TRANSMITTAL OF THE EXPLANATION OF SIGNIFICANT DIFFERENCES TO THE RECORD OF DECISION FOR SOLID WASTE MANAGEMENT UNITS 1, 211-A, 211-B, AND PART OF 102 VOLATILE ORGANIC COMPOUND SOURCES FOR THE SOUTHWEST GROUNDWATER PLUME AT THE PADUCAH GASEOUS DIFFUSION PLANT, PADUCAH, KENTUCKY, DOE/LX/07-2480&D1

**DOE/LX/07-2480&D1
Primary Document**

**Explanation of Significant Differences to the
Record of Decision for Solid Waste Management Units 1,
211-A, 211-B, and Part of 102 Volatile Organic Compound
Sources for the Southwest Groundwater Plume
at the Paducah Gaseous Diffusion Plant,
Paducah, Kentucky**

Date Issued—June 2022

Figure 3. SWMU 211-A Planned Injection Layout

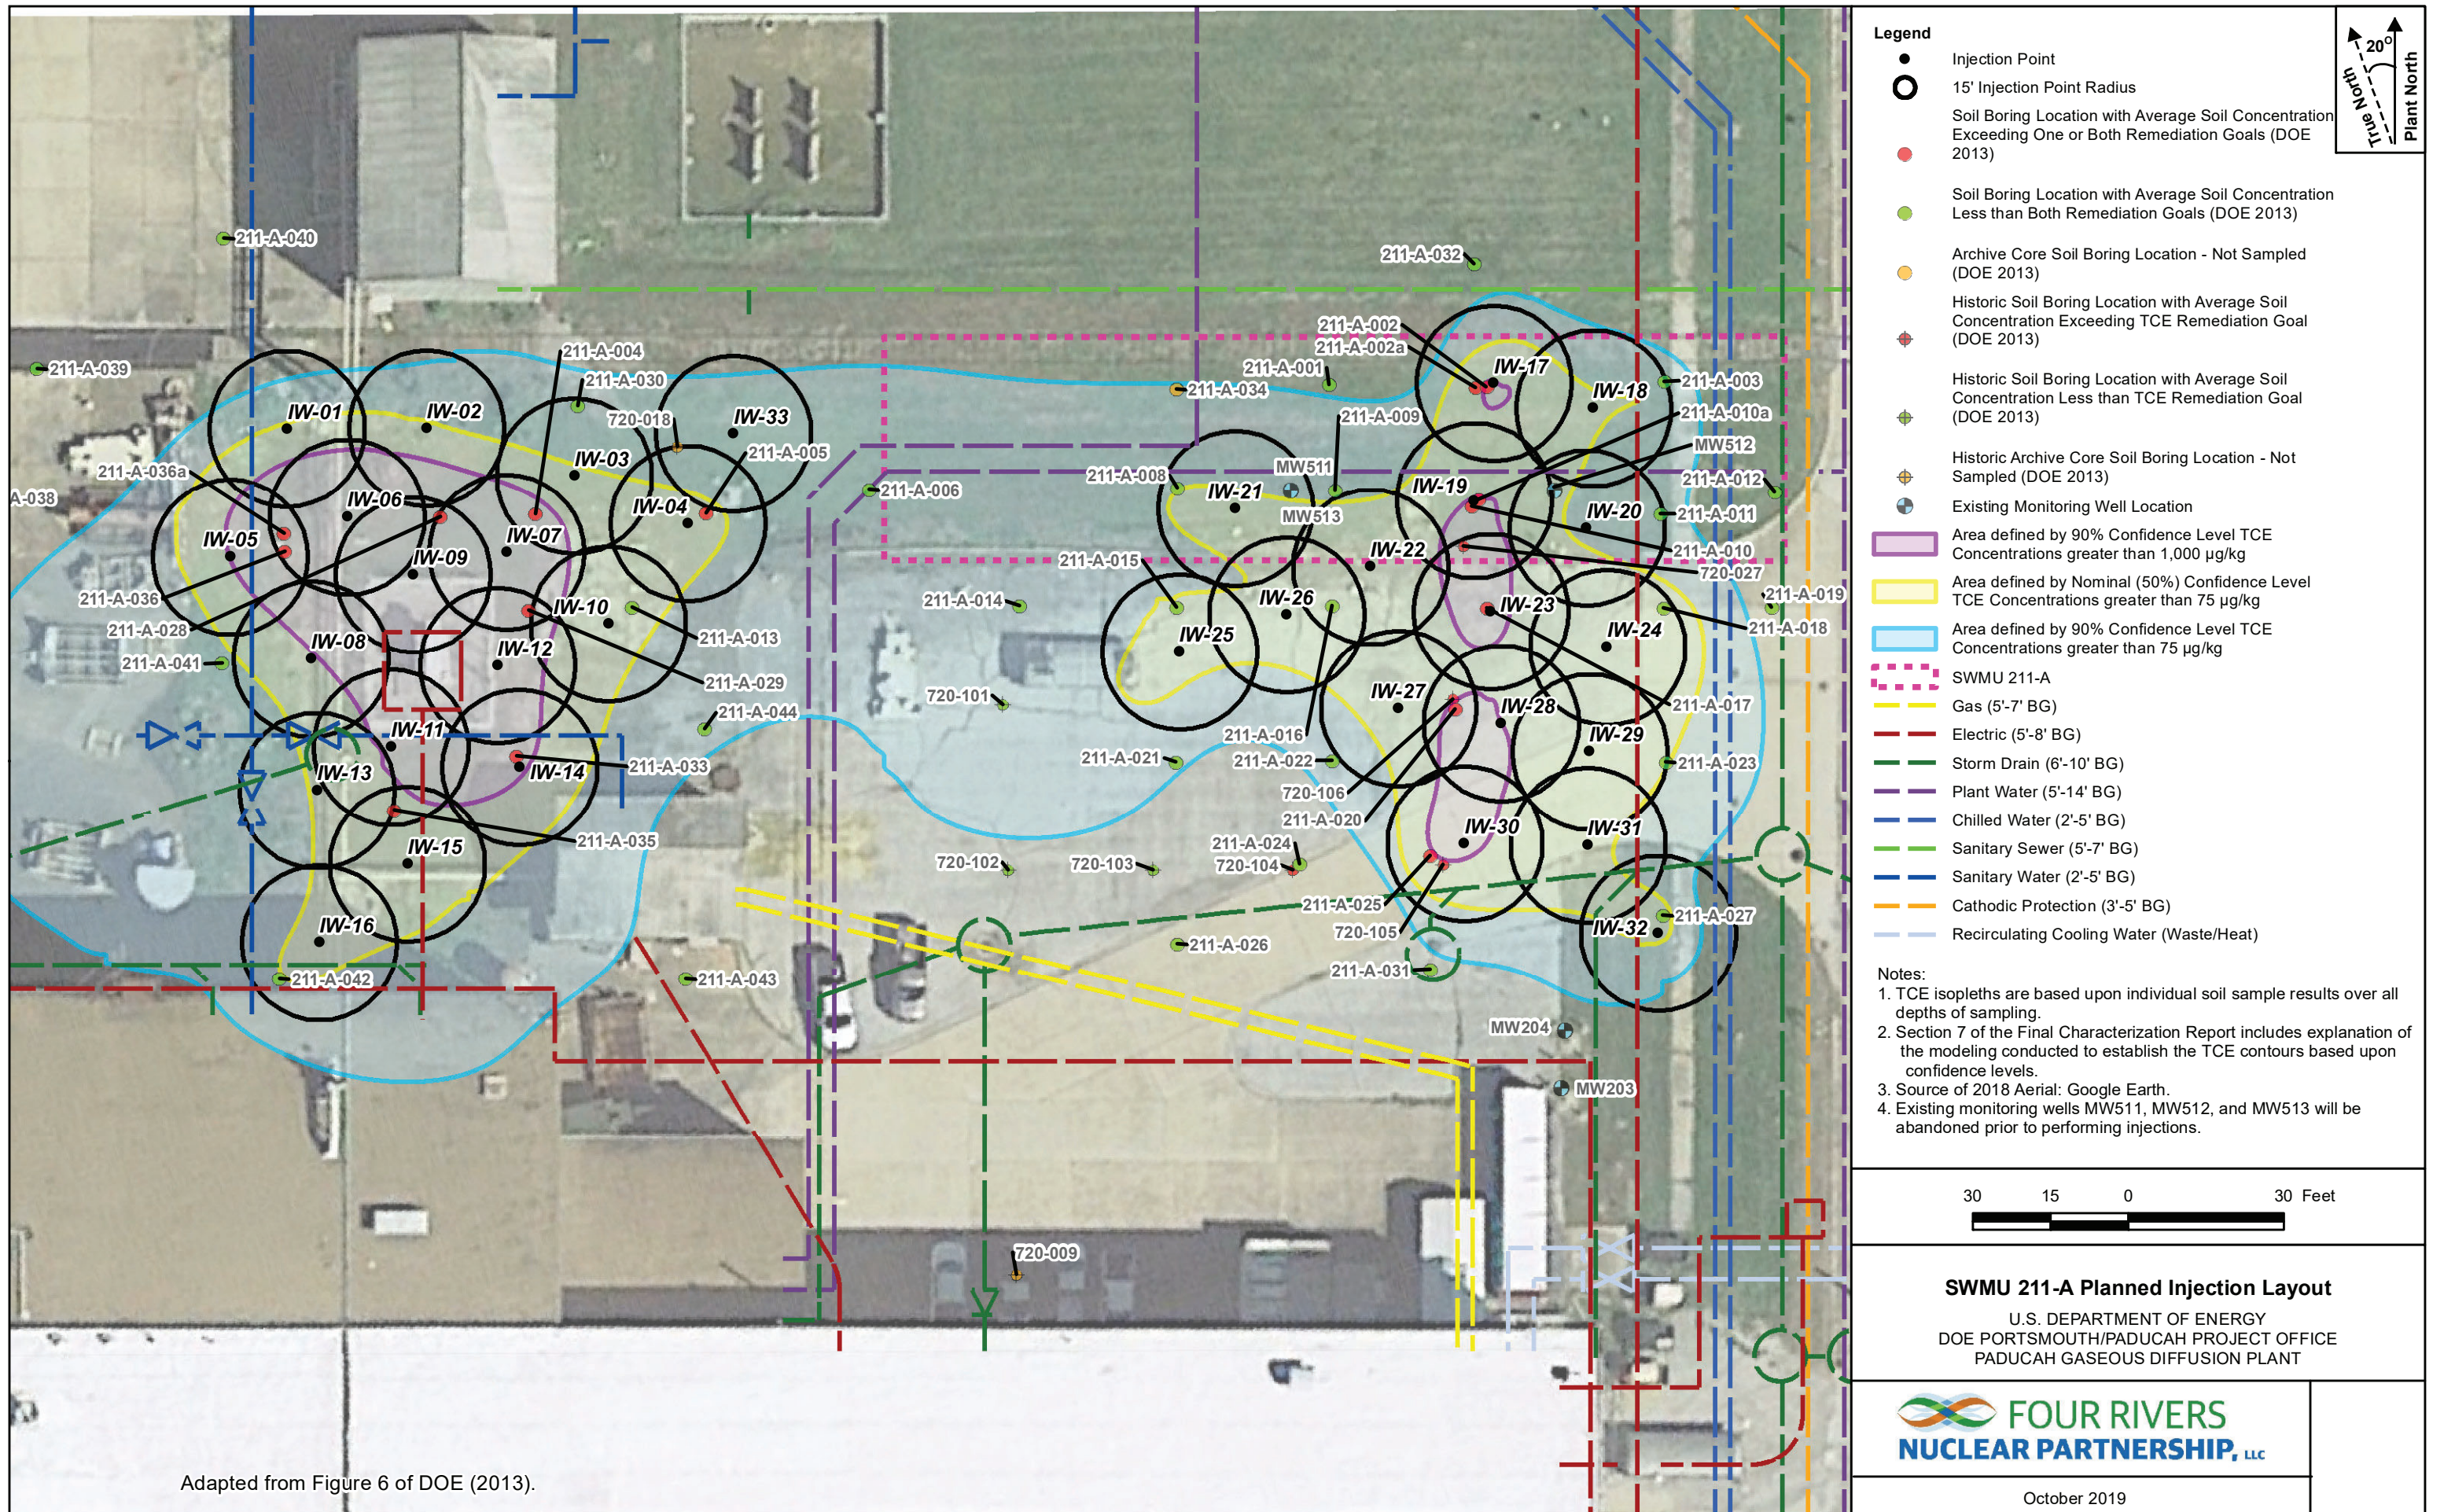
An RDR has been developed to support the specific implementation of Alternative 8, *In Situ* Source Treatment Using Enhanced *In Situ* Bioremediation with Interim LUCs, at SWMU 211-A (DOE 2019). EISB will be performed on the SWMU 211-A treatment area (see Figure 3). The recommended implementation of EISB increased the treatment area size and resulted in an increase of the following:

- Injection wells—33 locations (85 wells) from 6 locations (18 wells) in the ROD;
- MW network—9 wells external to the treatment area from 4 wells in the ROD; and
- Performance MW network—18 wells internal to the treatment area from 0 wells in the ROD.
